Whenuapai Green Integrated Transport Assessment

Prepared for	Neil Construction Limited
Job Number	TNEGL-J002
Prepared by	Mat Collins, Associate Transport Planner Chris Blackmore, Principal Transport Planner
Reviewed by	Dave Smith, Technical Director

Date issued	Status	Approved by
19 December 2023	For client comment	Dave Smith
1 February 2024	For Council and AT pre-lodgement comment	Mat Collins
17 December 2024	Clause 23 responses added as appendices	Mat Collins

Figure 5.1 Whenuapai Green Precinct Plan

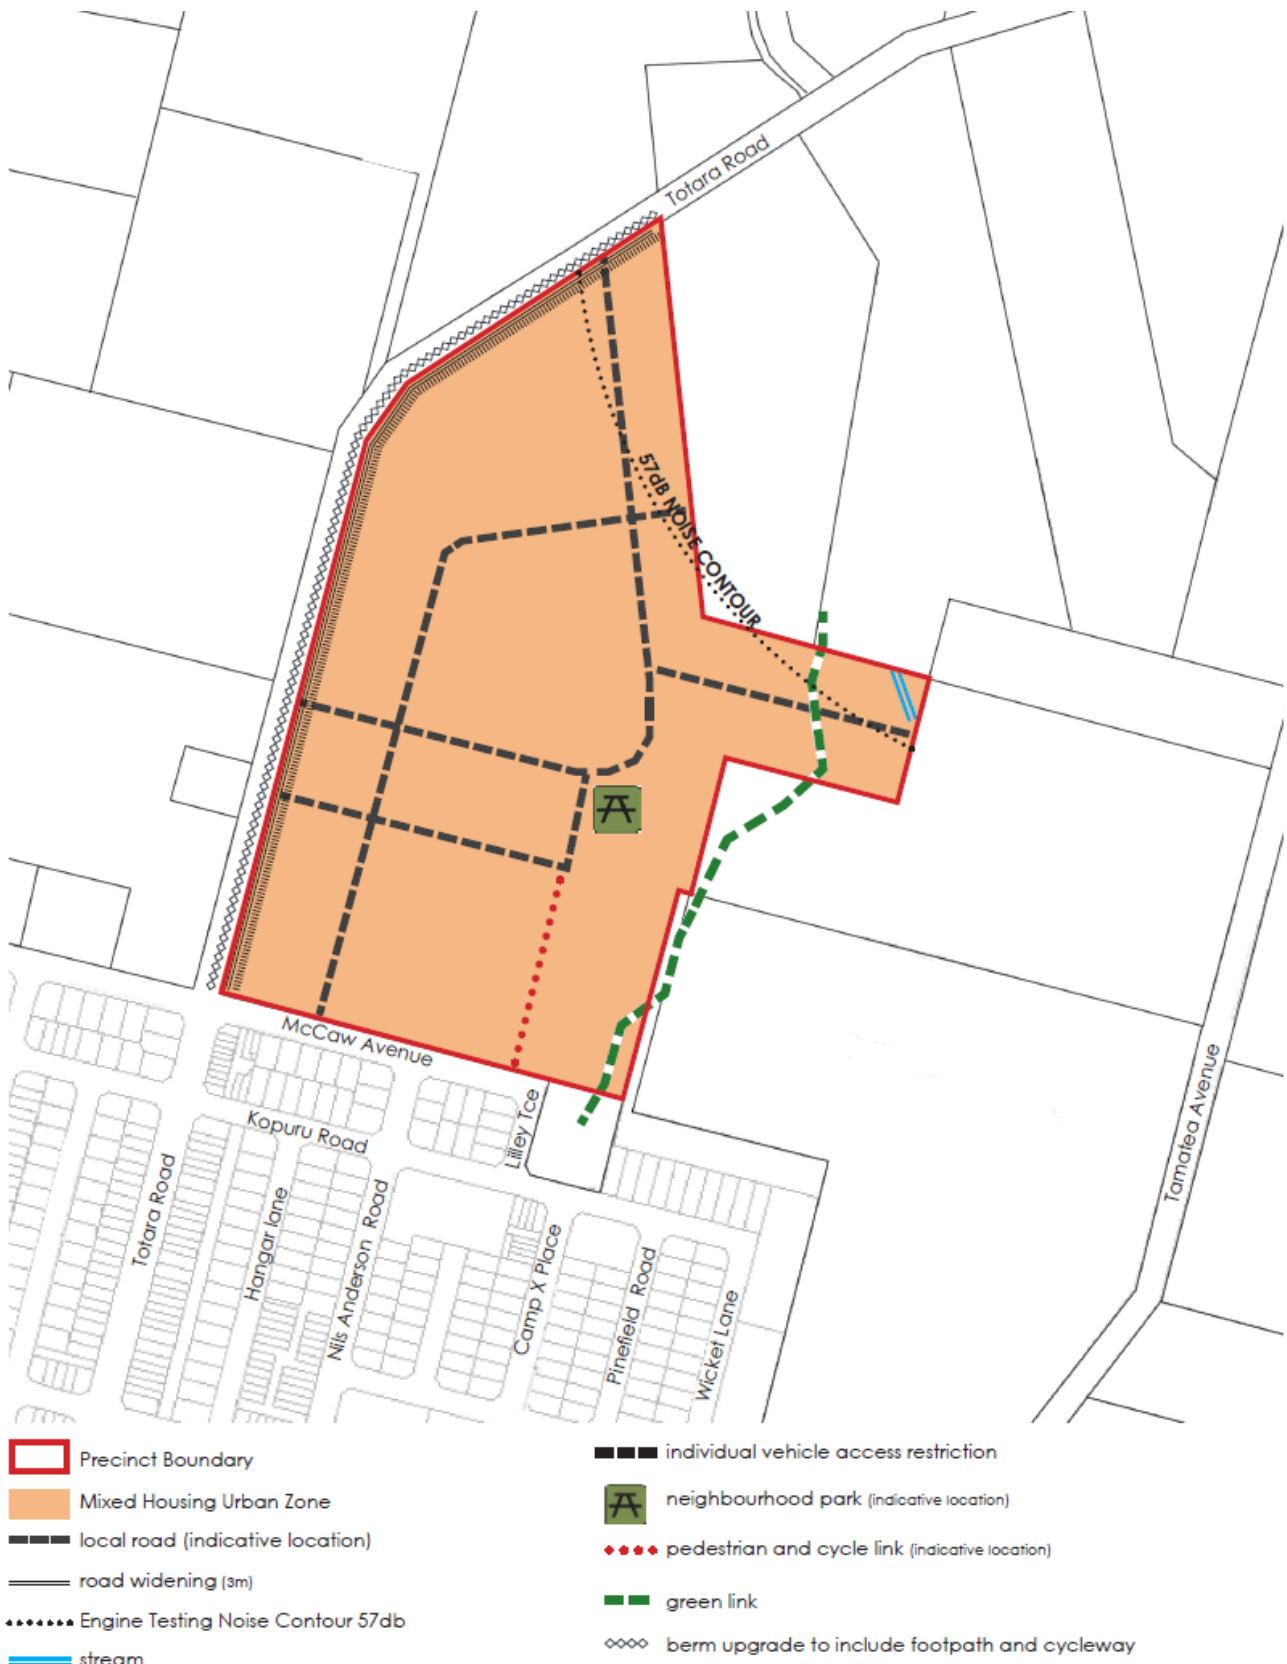
Specific request	Reason for the request
<p>Please clarify the suggested "individual" vehicle access restriction requirements on Tōtara Road</p>	<p>Figure 5.1 of the ITA shows 'individual vehicle access restriction' along the Tōtara Road frontage. It is not explained what these restrictions would involve (they may be in the proposed precinct provisions, which we do not have).</p> <p>We note that these access restrictions are not referred to in the Precinct Plan maps or provisions.</p>

Figure 5.2 Road cross sections, for inclusion in the Precinct Plan

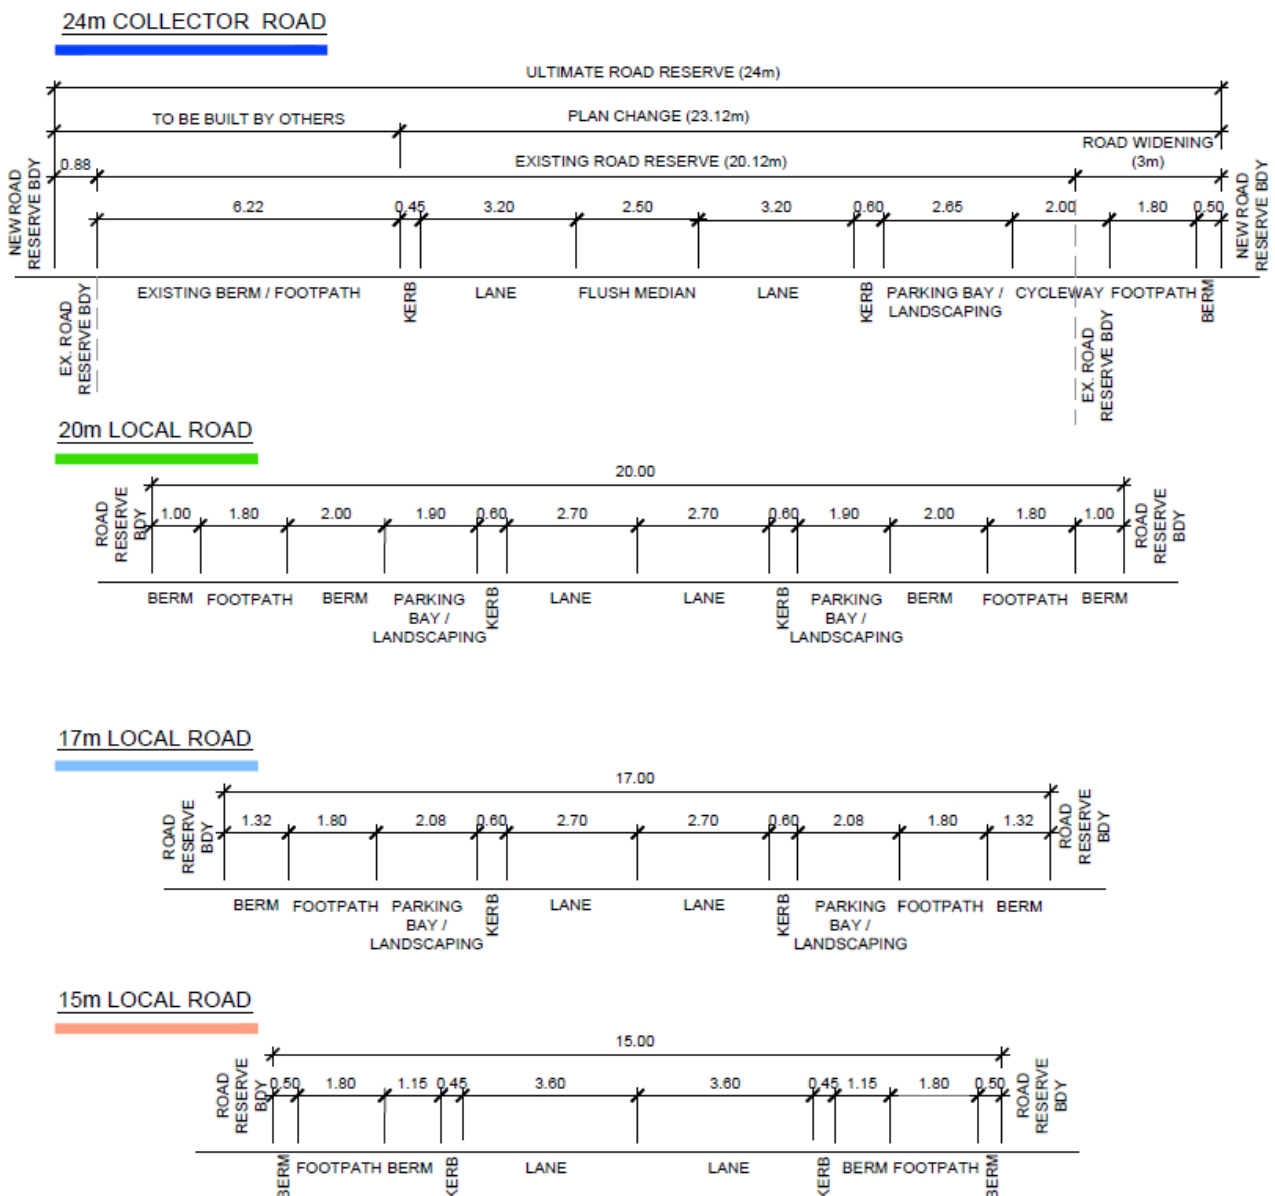
AT has previously advised (for Fast Track proposal) that a minimum 1m berm is required. A 0.5m berm is still shown in Figure 5.2 for the 24m collector road.

Figure 2.3 Proposed Precinct Plan, showing the location of the previously proposed road link to NZDF land.

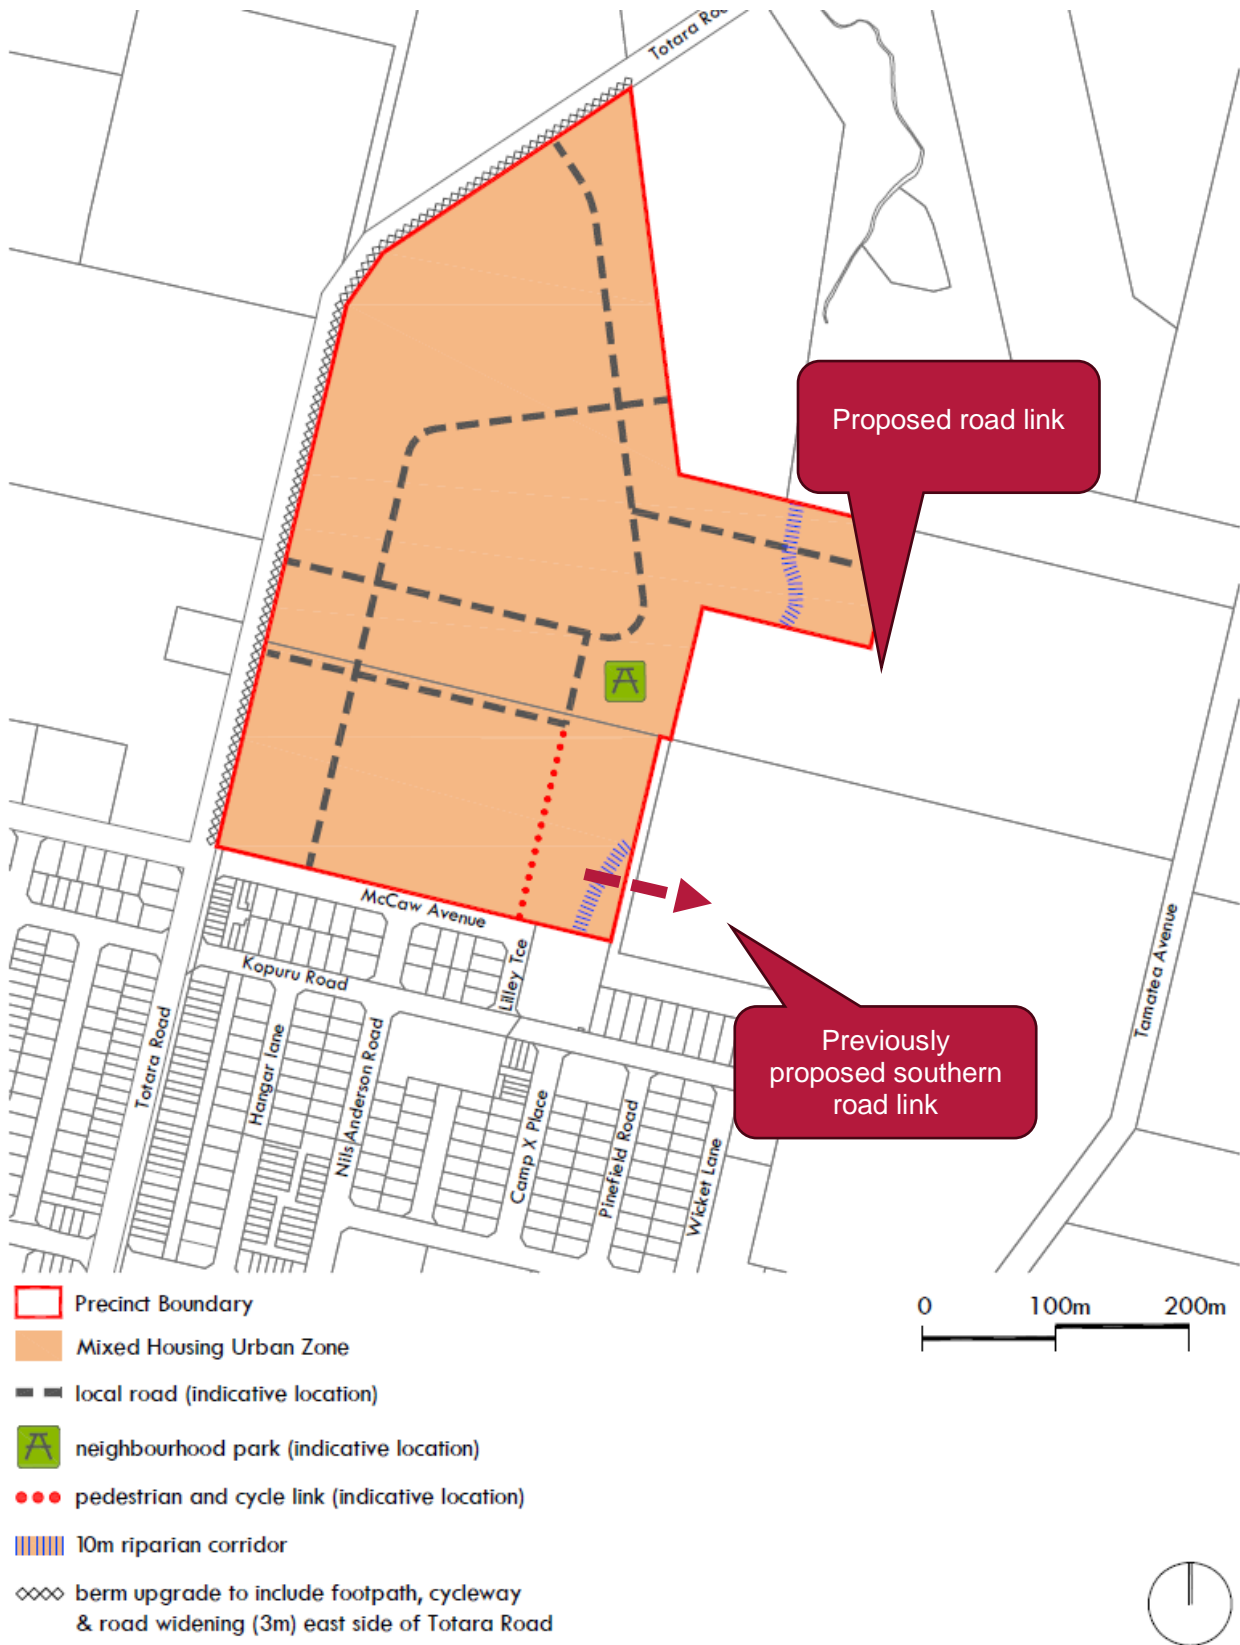
Specific request	Reason for the request
Please advise how the ends of the local roads would be constructed in the interim, given that full connections into 94 Tōtara Road and the RNZAF Base may not be immediately provided in those sites.	<p>The ITA states that “Two future proofed road connections to Royal New Zealand Air Force (RNZAF) Base Whenuapai and 94 Tōtara Road.” The local road connection points are shown in Figure 5.1. The connections within those sites may not be provided until those sites are fully developed, so interim solutions such as turning heads could be required in the short to medium term. The future connection to the RNZAF Base may require additional consideration as this is currently closed off to the public, and the Ratarā Stream would need to be crossed.</p> <p>While the local roads are indicative and subject to detailed design, understanding the viability of future connections will provide an understanding of whether or not the proposed connections are feasible.</p>

The Fast Track application included a third future road connection, shown in the location marked in Figure 2.3. We understand that, after lodgement of the Fast Track application, NZDF has indicated that

the southern link is not required and that the northern link is sufficient. We have assessed the proposed indicative internal road transport network and conclude that it appropriate from a transport perspective for the reasons outlined within the ITA. Note that the Whenuapai Green fast track application was prepared under separate legislation and independently of this private plan change process.
